PARKER AND PINE FILING NO. 1 LOT 2 – SITE PLAN

3RD SUBMITTAL 10/05/2020

COVER SHEET
 MURPHY EXPRESS
 12405 SOUTH PARKER ROAD
 PARKER
 COLORADO

SHEET NO. A1.3

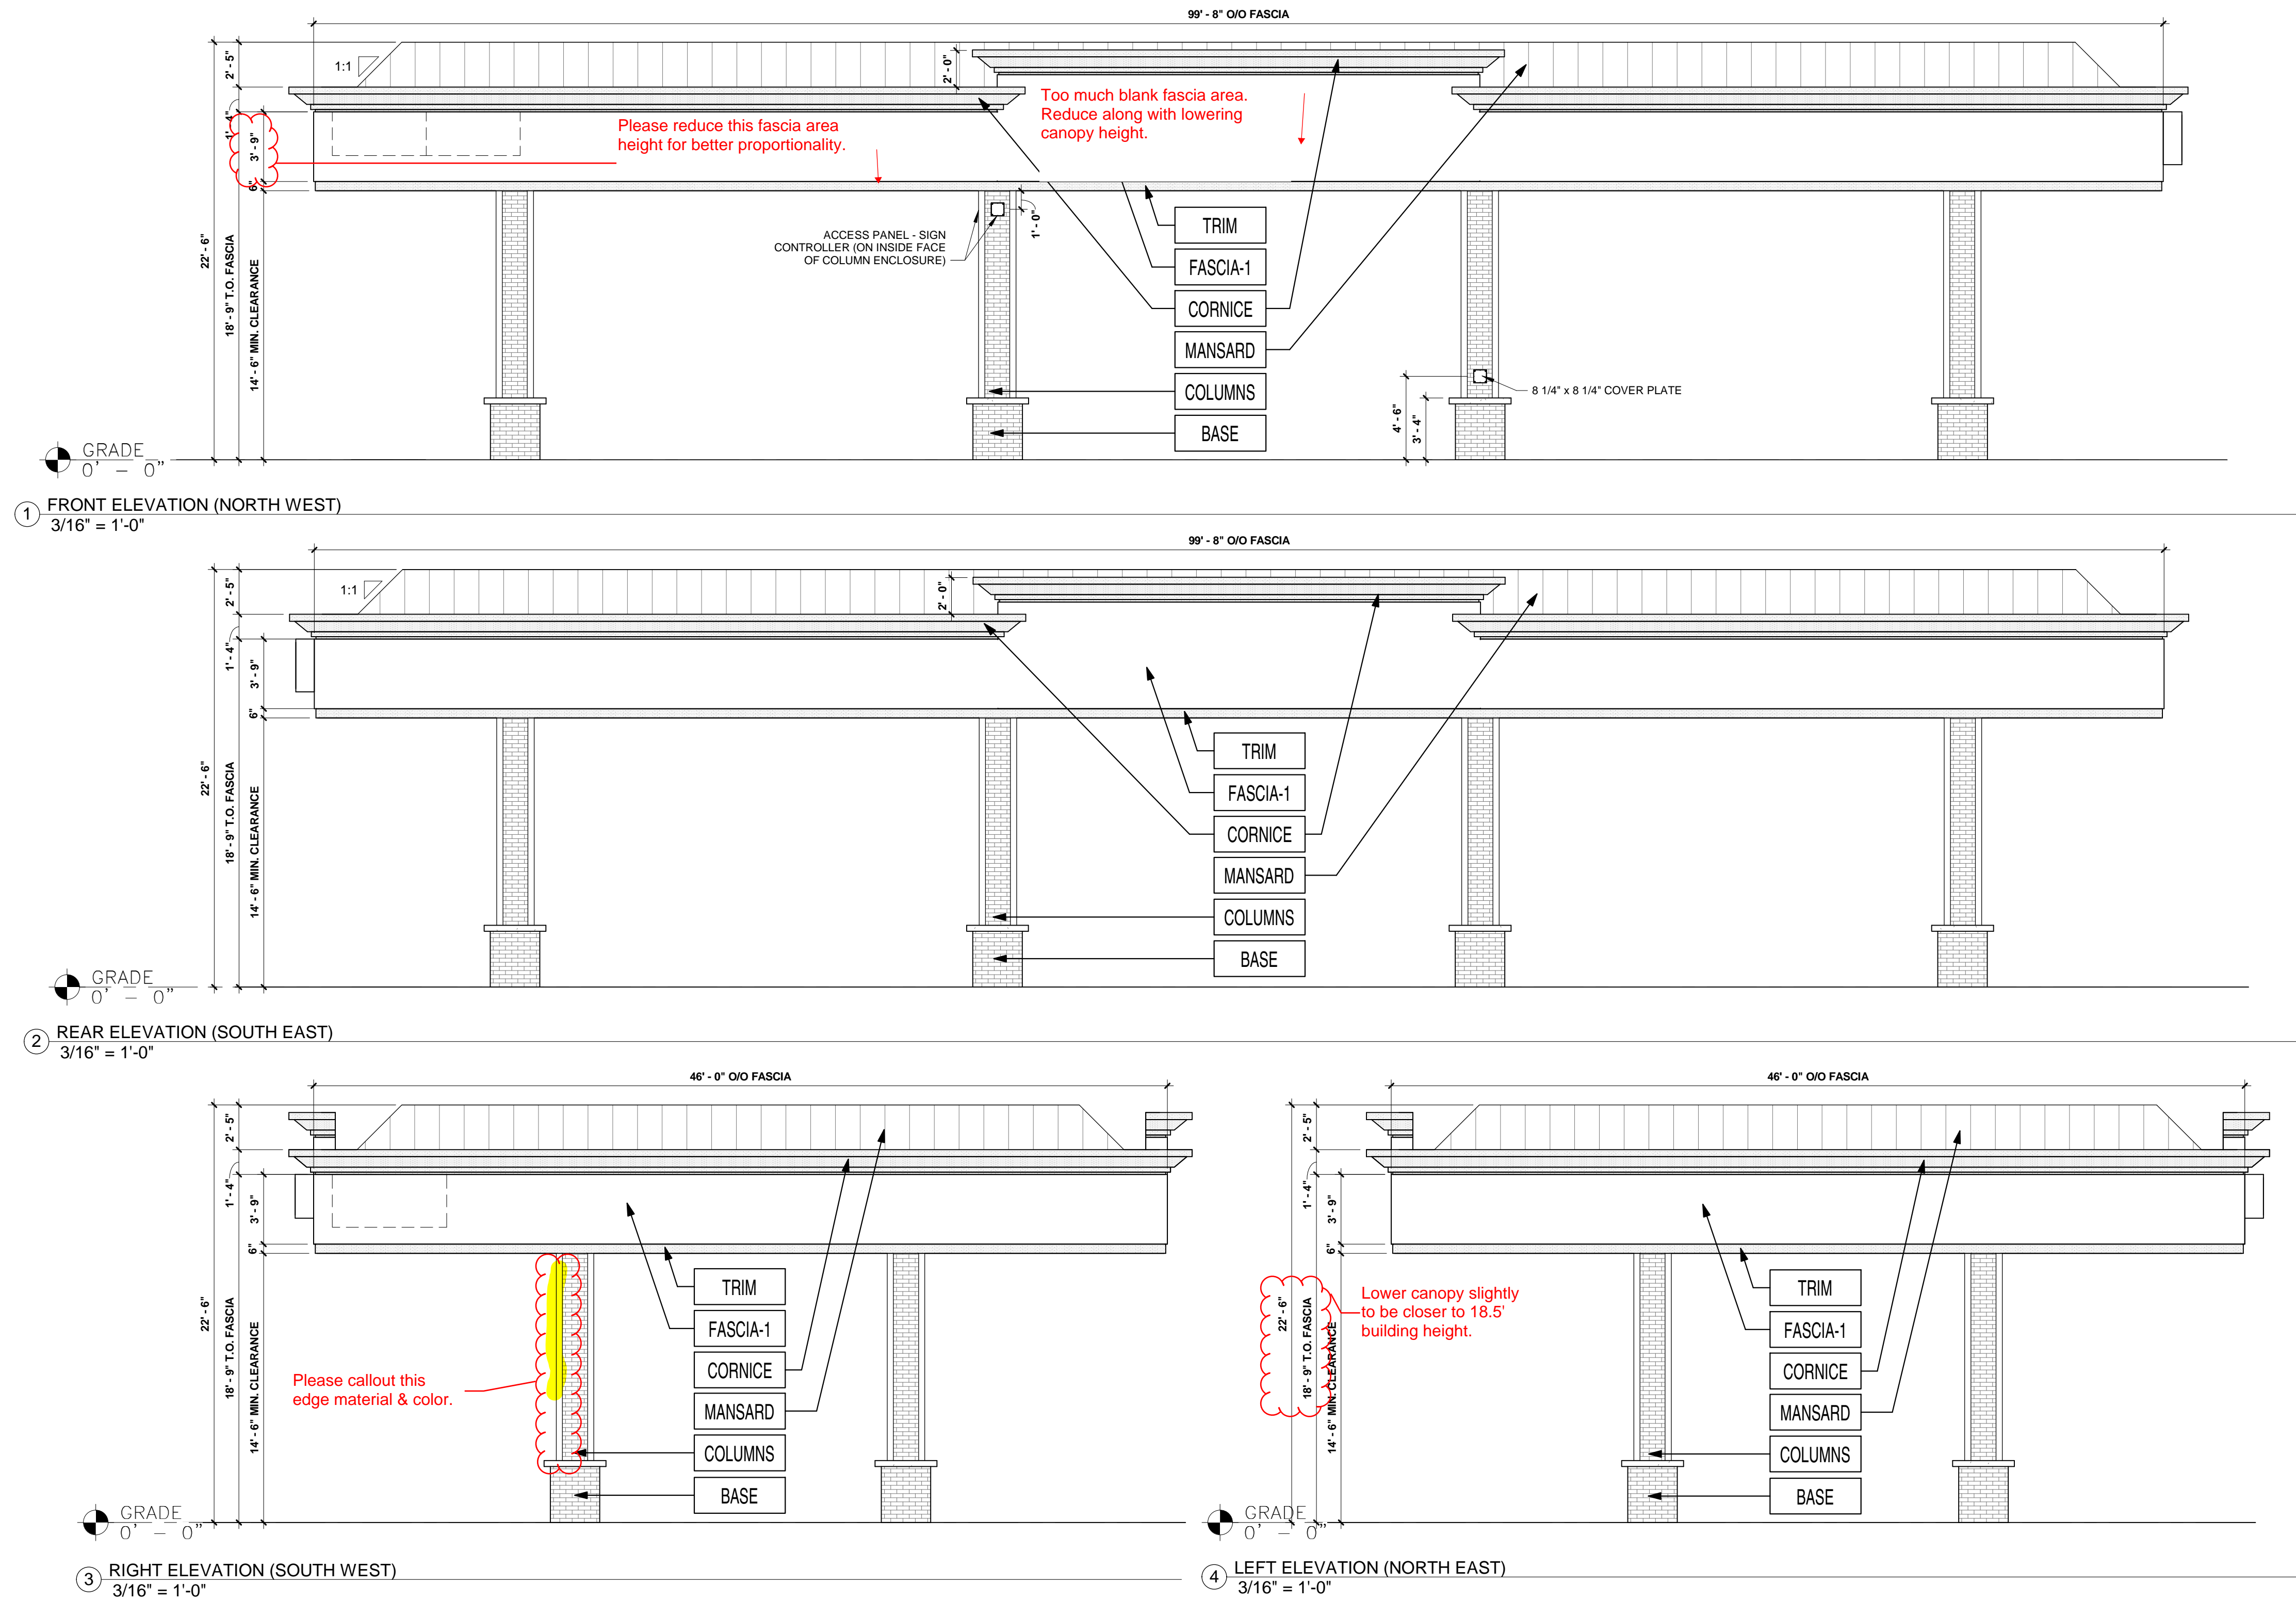
Roof sample required with material board & not provided. Please provide.

Too much blank fascia. See comment sheet A1.3. Revise color to meet PD allowed colors such as grey or black. This comment also applies to the C-store building.

Revise to an approved/allowed PD color such as grey or black

Please provide views of the roof and show all rooftop mechanicals, their screening (parapet detail) & their dimensions.

Revise color to PD approved charcoal/black or grey on all window trellis canopies.

Add double soldier course to break up this expanse of brick wall

1. Large expanse of brick. Please add a double soldier course or similar to break it up.

2. Brick sample provided 11.18.20 is a darker solid (dark sand) color and does not resemble the color renderings. The brick sample is not a full size brick veneer & therefore staff cannot discern if the brown brick provided is naturally variegated in color as depicted in the renderings. Please clarify & revise renderings accordingly.

3. Colors and materials do not meet the standards of the Parker & Pine PD Guide. Please revise to meet the colors and materials below. New material/color samples will be required for review.

Please revise front entrance canopy with a more current look using prescribed PD colors charcoal/black or gray (example pic shown).

See comment 3 on this page & example pic to the right. Revise all fascia on this building with a more current/modern material such as the PD 'two-tone' wood panels or metal panel system that provides texture & visual interest - and aligns with the PD Guide.

Add single soldier course to break up

Municipal code prohibits faux windows. Please change to typical clerestory windows. See comment to enlarge height of the clerestory

EXAMPLE: Use similar grey metal panel system in lieu of proposed low quality sheet metal which has no texture or visual interest. Pergola canopies at public entrances to match.

Signs processed via a separate Sign Permit application. Please remove from site plan set.

Exterior elevations have been revised after significant correspondence with town staff. Fully updated/revised elevations have been included in this resubmittal that is the culmination of those discussions. Let us know if you need anything else to approve.

Exterior elevations have been revised after significant correspondence with town staff. Fully updated/revised elevations have been included in this resubmittal that is the culmination of those discussions. Let us know if you need anything else to approve.
